NAVIGATION - STALL WARNING HORN REPLACEMENT

The original stall warning horn is no longer available. If the stall warning horn needs to be replaced, a new stall warning horn is available and will require an additional bracket for installation.

CQB-34-01
Page 1 of 18

Figure 5. After Modification (Sheet 1)

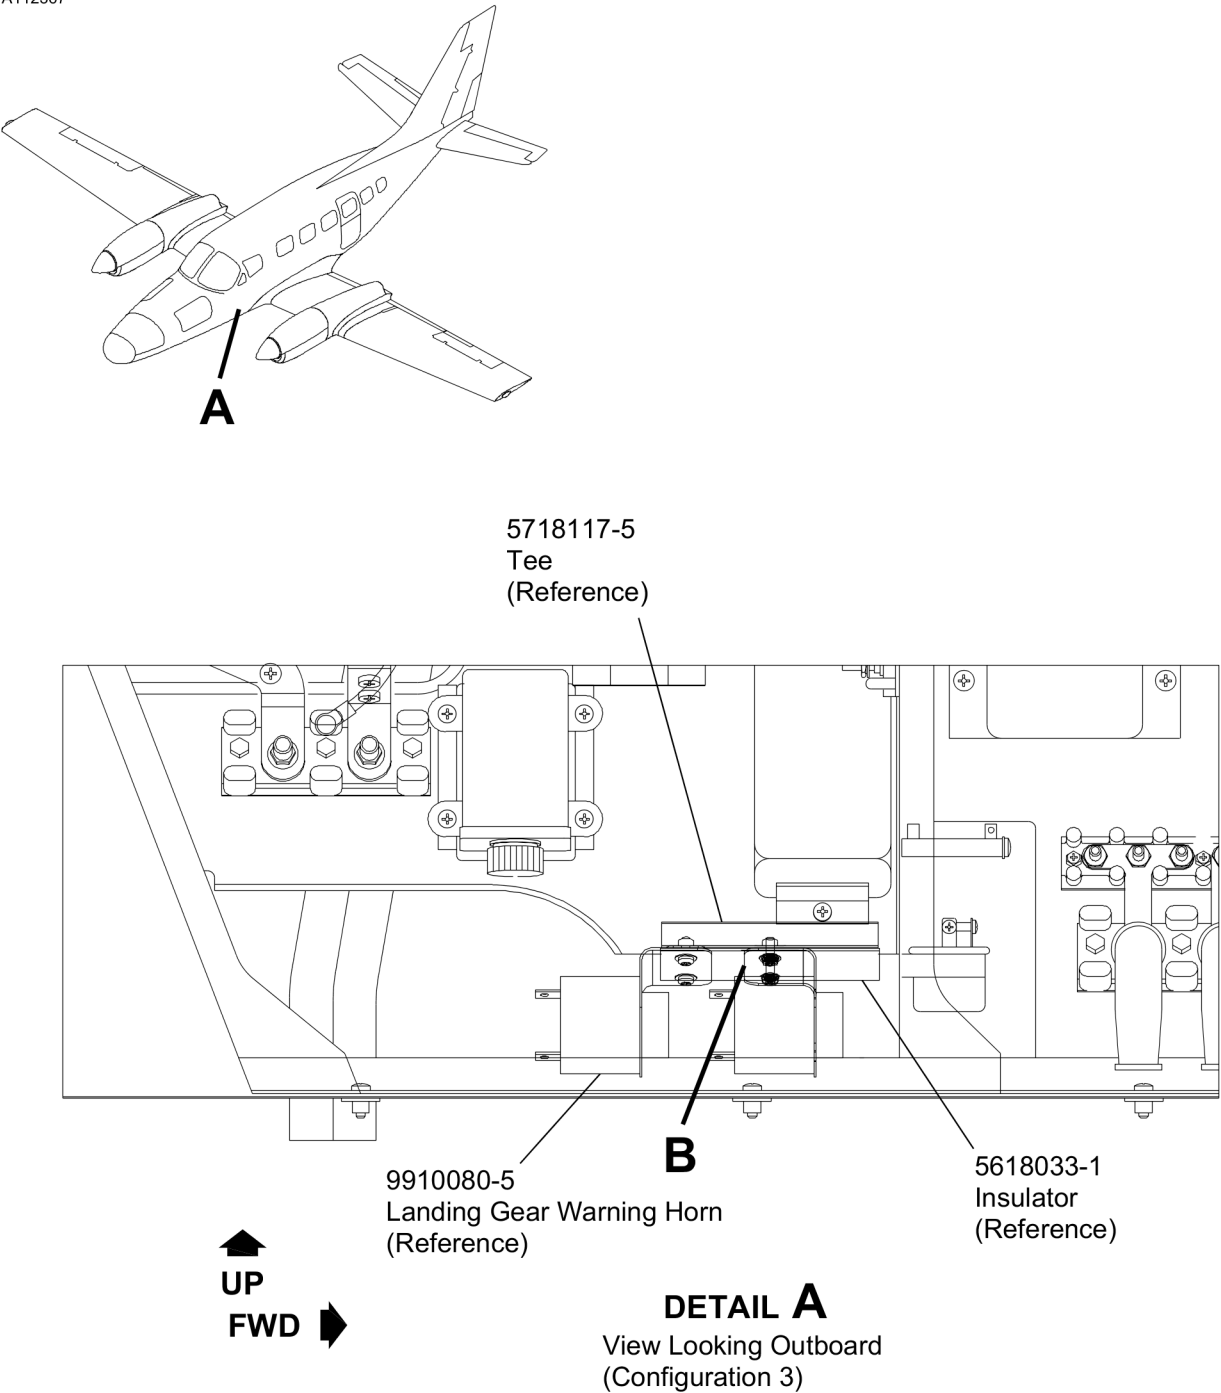
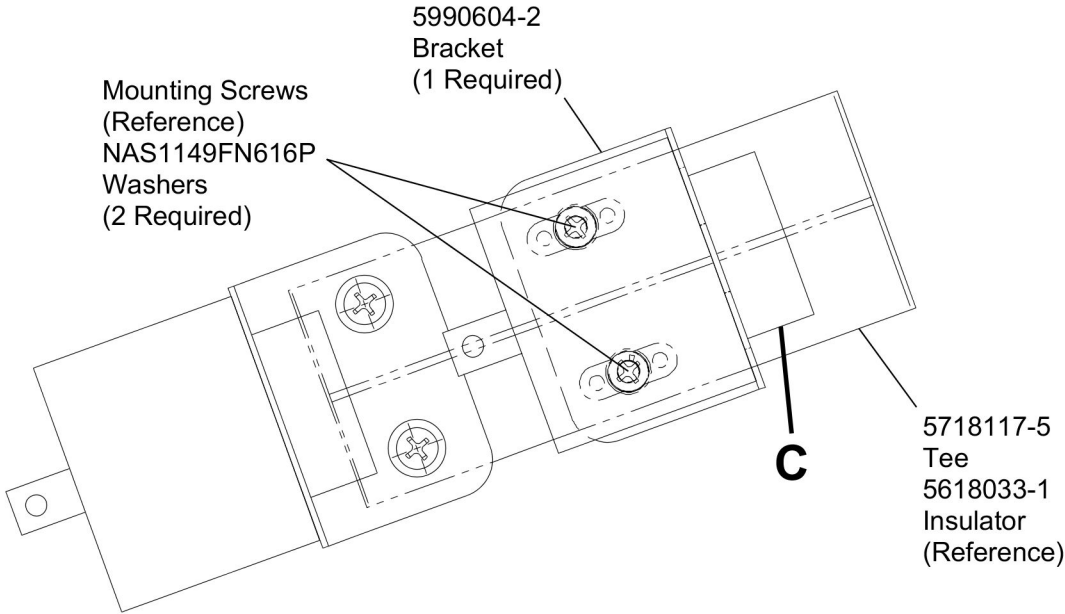
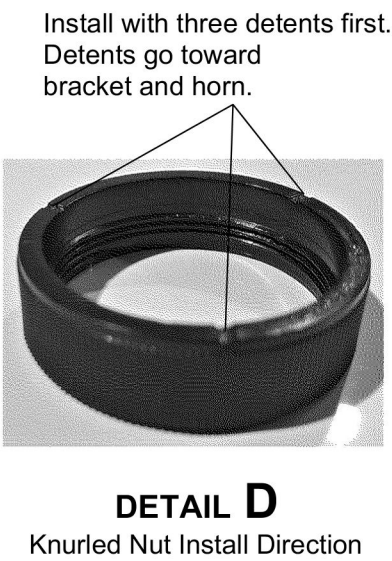
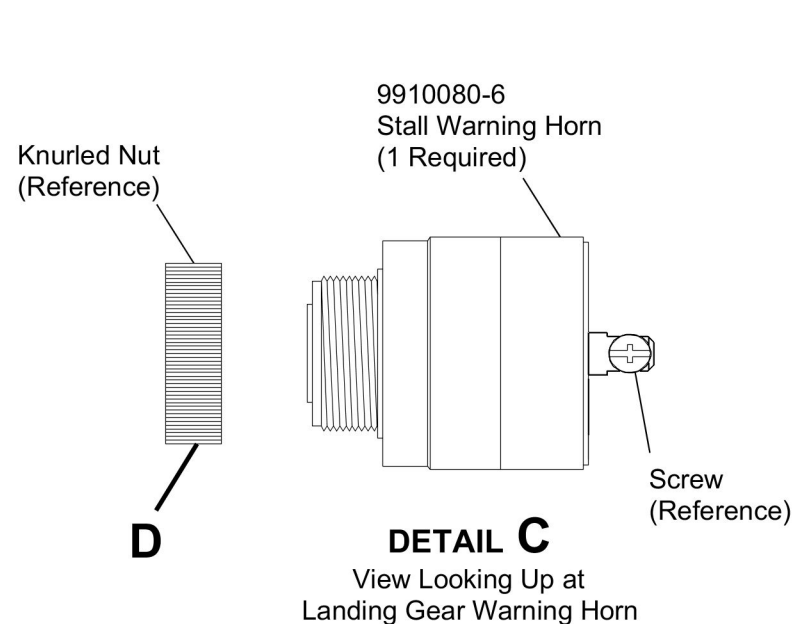
16. (Refer to Figure 5, Sheet 1 and 2.) Install the 9910080-6 Stall Warning Horn as follows:

- A. Put the 5990604-2 Bracket onto the existing holes of the 5718117-5 Tee.
B. Install the two mounting screws with two NAS1149FN616P Washers into the 5990604-2 Bracket.
C. Install the 9910080-6 Stall Warning Horn into the 5990604-2 Bracket.
D. Install the knurled nut onto the 9910080-6 Stall Warning Horn.

NOTE: The plastic knurled nut must be installed with the three indents toward the bracket and horn assembly. On the internal circumference, the smooth side without threads is installed first, towards the bracket and horn. This technique of installation will make sure the nut fully seats against the bracket and not bottom-out on the threads. If not installed correctly the knurled nut will bottom-out on the threads and the horn assembly will not be fully tightened to the bracket.

- E. Install the wiring and screws into the 9910080-6 Stall Warning Horn.
